BID ADDENDUM NO. (3)

South Seneca CSD

2022 Capital Improvement Phase II

2541.040

AD3-A1 – SALT SHED SITE PLAN

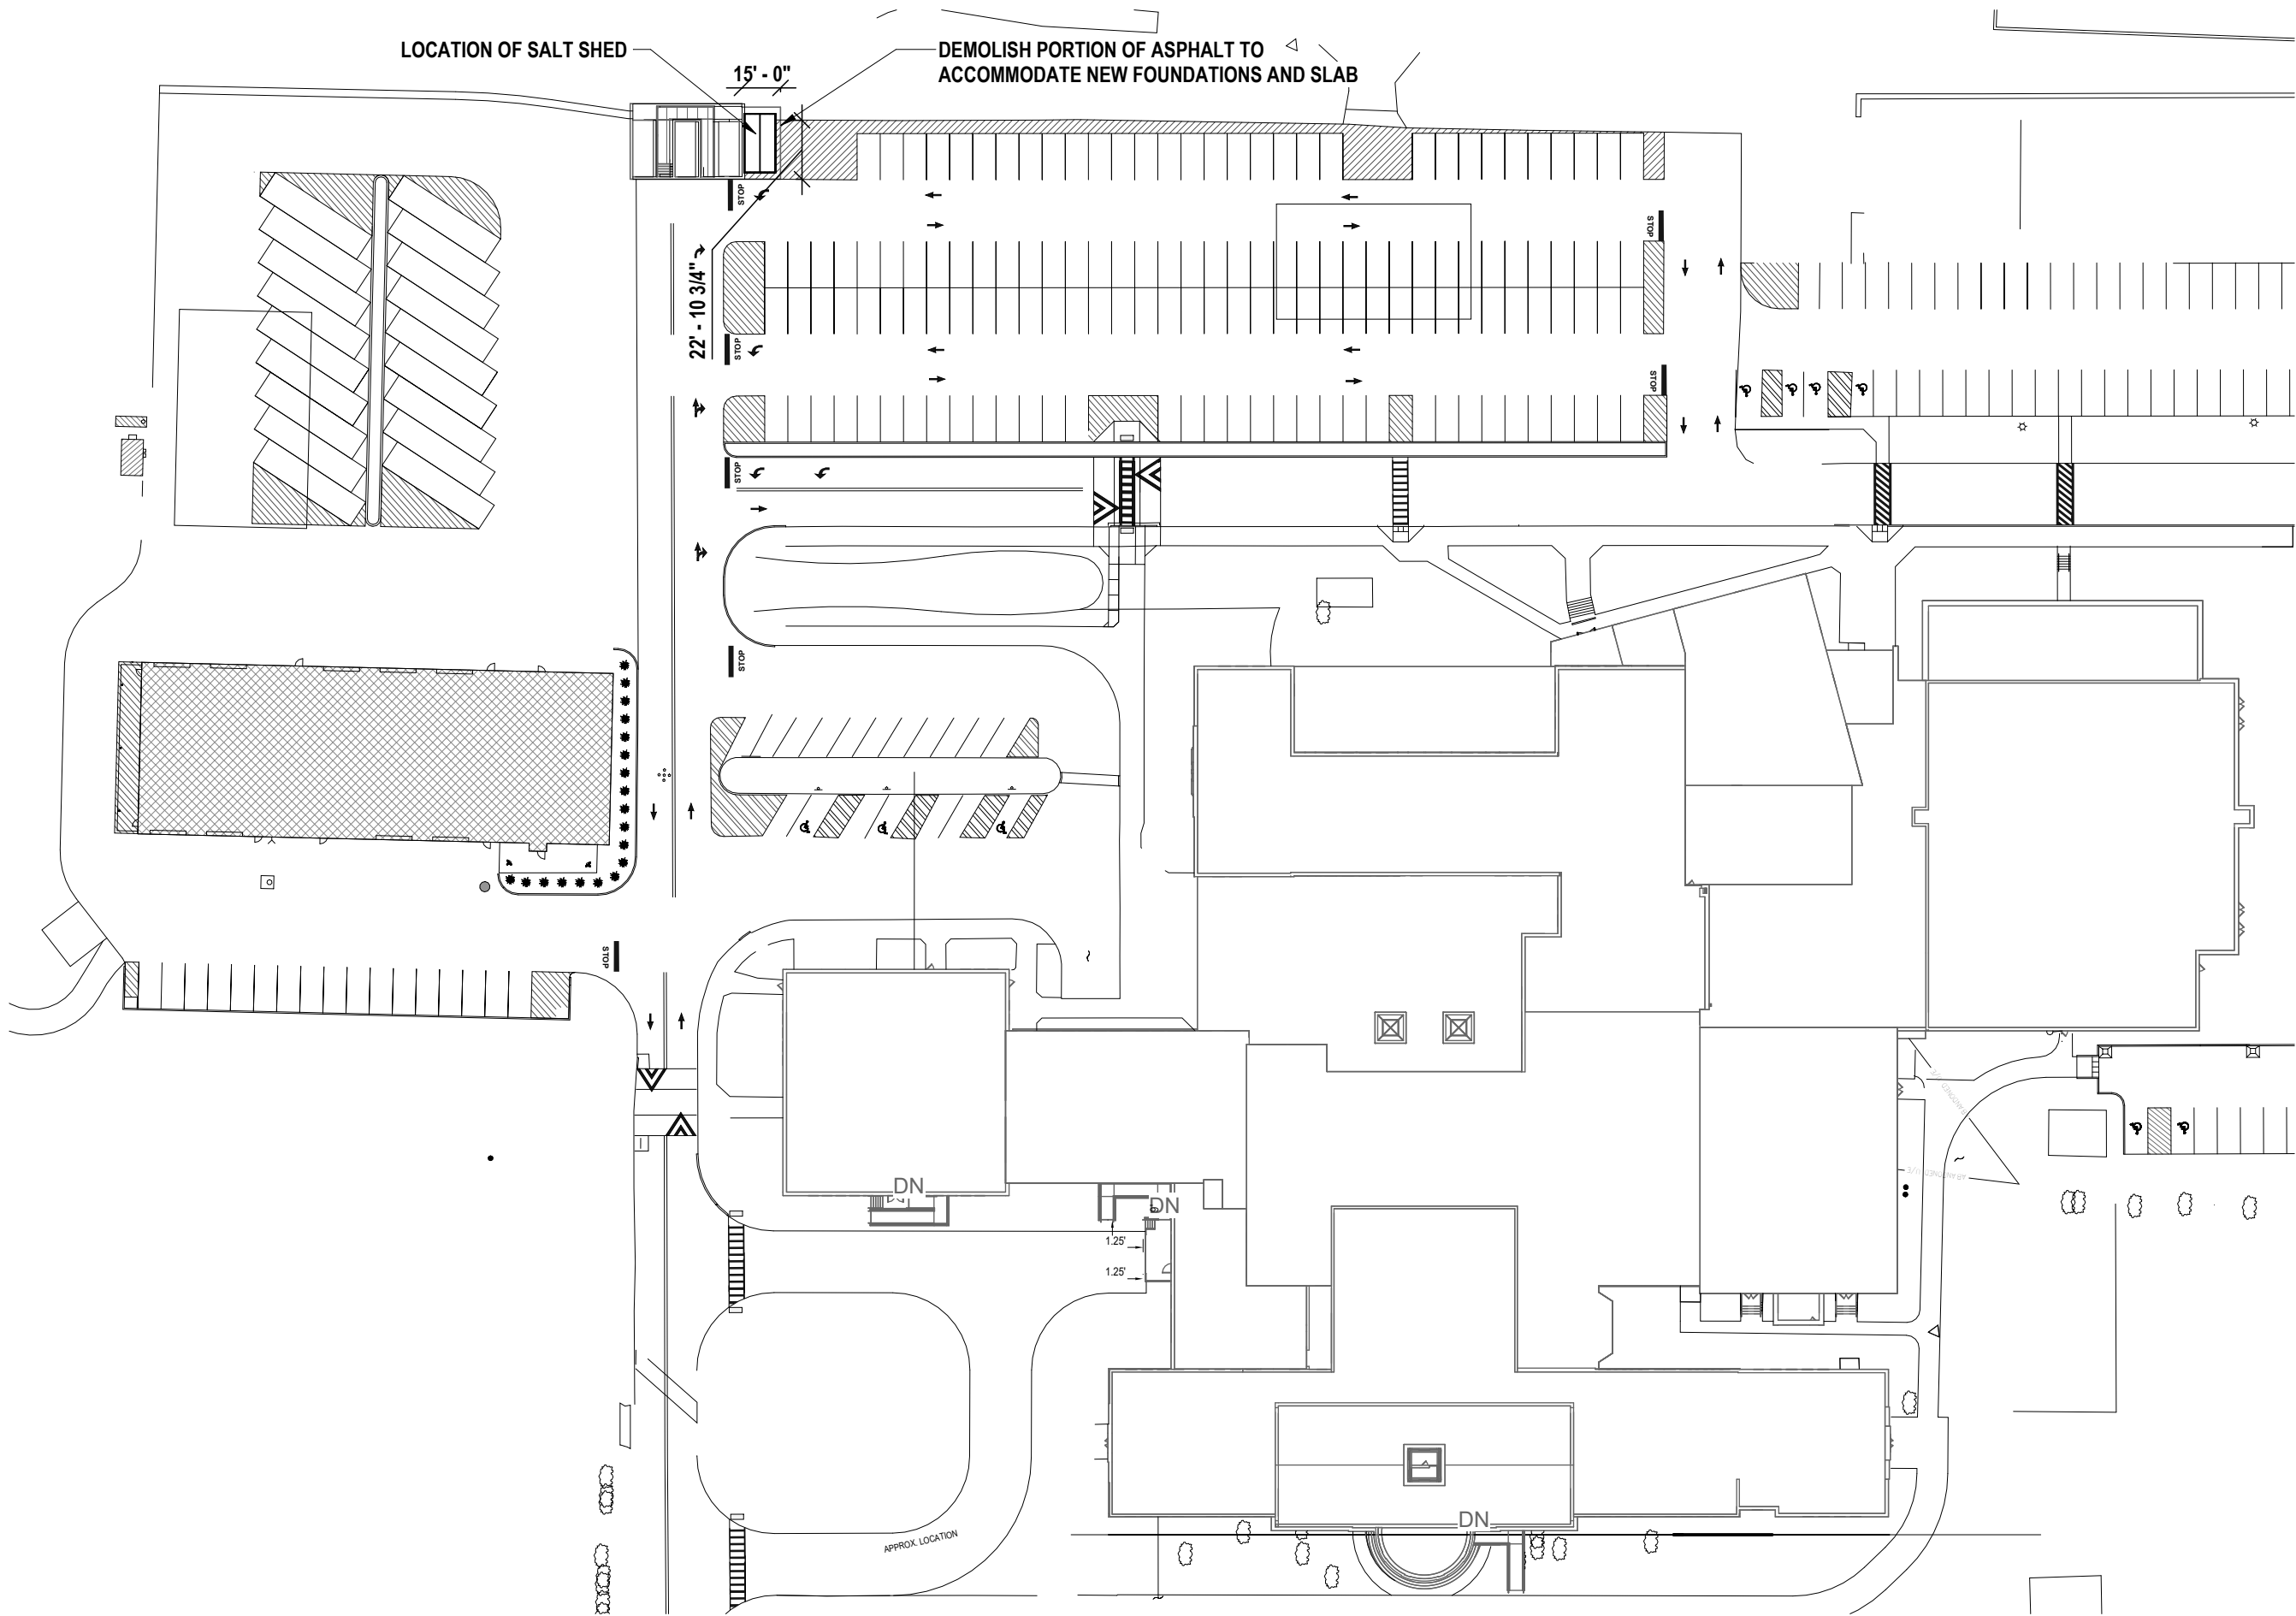
ITEM AD2-1 Refer to HS-A1.1 – FIRST FLOOR PLANS AND DETAILS

ADD Detail 1 per AD3-A1 issued by this addendum.
